IEEE P802.15 Wireless Personal Area Networks

Project	IEEE P802.15 Working Group for Wireless Personal Area Networks (WPANs)	
Title	TG3 Draft D08 to D09 changes	
Date Submitted	[1 December, 2001]	
Source	[James P. K. Gilb] [Mobilian] [12707 High Bluff Dr., Suite 335, San Diego, CA 92130]	Voice: [858-436-2201] Fax: [858-436-2301] E-mail: [gilb@ieee.org]
Re:	[]	
Abstract	[This document is contains the issues and resolutions developed by the TG3 subcommittee at the Rolling Meadows ad-hoc meeting. It also serves to document the addtions made to the draft standard D07 to produce D08.]	
Purpose	[To provide a record of the resolutions of TG3 and the changes to the draft standard D07 to make D08.]	
Notice	This document has been prepared to assist the IEEE P802.15. It is offered as a basis for discussion and is not binding on the contributing individual(s) or organization(s). The material in this document is subject to change in form and content after further study. The contributor(s) reserve(s) the right to add, amend or withdraw material contained herein.

1. Changes from “Austin Draft Ammendements,” document 01/496r2

Maximum allocation delay

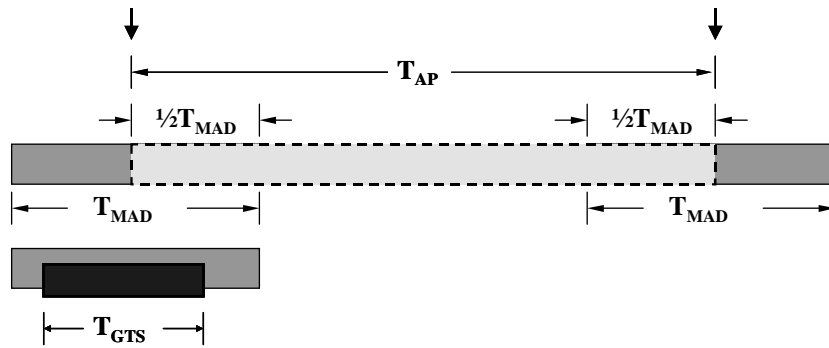
- a) T_{MAD} defines an allowable time jitter to the allocation of time slots by the piconet coordinator, PNC.
- b) The maximum allocation delay starts before the end of the allocation period, but does not affect the PNC's reference timing of the T_{AP} period. It allows some variability in position of the GTS slot(s).

Ed. action: Change the CTRB to match the figure. The new figure and new text are below:

Figure 8—Illustration of the position of T_{MAD} within T_{AP}

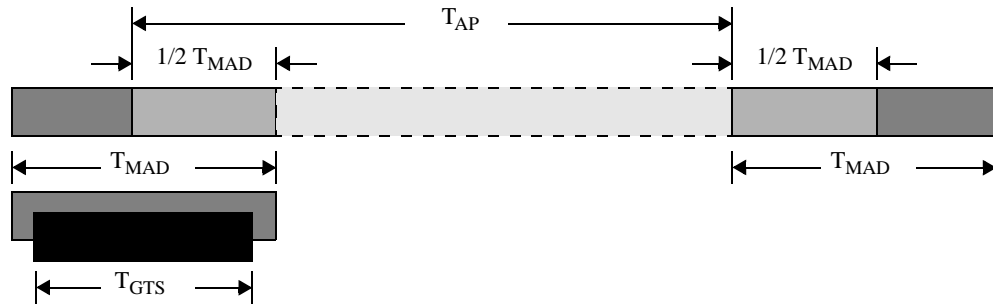
The maximum allocation delay starts before the end of the allocation period, but does not affect the PNC's reference timing of the T_{AP} period. This allows some variability in position of the GTS(s). The DEV determines this time based on the jitter requirements of the data stream that it needs to send. Figure ?? illustrates the position of T_{MAD} within T_{AP} . The T_{GTS} time is the total amount of slot time that needs to be allocated within the T_{MAD} time centered around the start of the T_{AP} interval.

Figure 9—Possible GTS allocations that meet T_{MAD} requirements

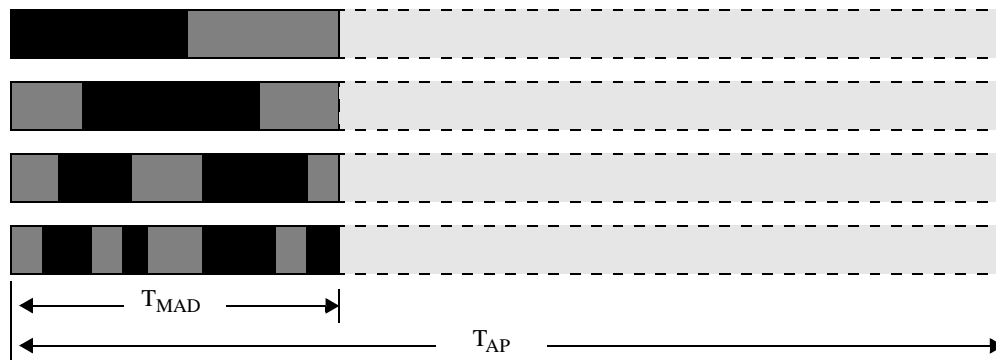
Based on the requirements for T_{MAD} within T_{AP} , the PNC has many possible ways to allocate the GTSs required by the DEV, as illustrated in .
